A July 7, 2022 letter from the Heart of the Valley Metropolitan Sewerage District (HOVMSD) was sent to the Outagamie County Recycling and Solid Waste Department (OCRSWD) requesting a proposal to accomplish the three objectives listed below to the satisfaction of HOVMSD and Village of Little Chute.

Foth Infrastructure & Environment, LLC (Foth), on behalf of the OCRSWD, submitted an August 29, 2022 proposal to HOVMSD and Little Chute (Proposal). The East Landfill (ELF) concepts are acceptable. The North East Landfill (NELF) concepts are not, particularly the proposed time to achieve a 70% ammonia load reduction. Specific concerns are outlined below.

North East Landfill Flow and Ammonia Situation

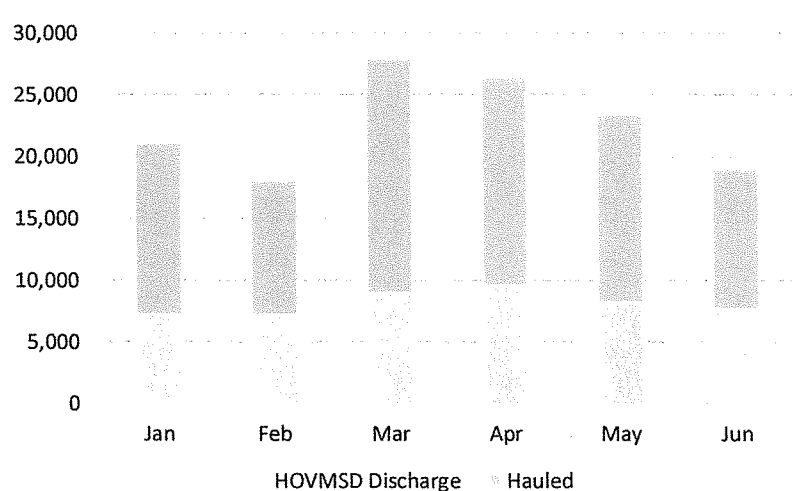
The Proposal outlines a concept to deliver to HOVMSD a consistent, pre-defined volume and flow rate. HOVMSD agrees with the concept. The specifics require more attention. For instance, to satisfy the 139 ppd-NH3 limit in the near term, the consistent flow rate will be small. The graphic below shows how small.

The average allowable leachate volume will be less than 10,000 gpd or, if delivered consistently over a 24-hour period, less than 7 gpm. The pumping, metering, and sampling equipment must perform well and reliably at flows in the vicinity of this value.
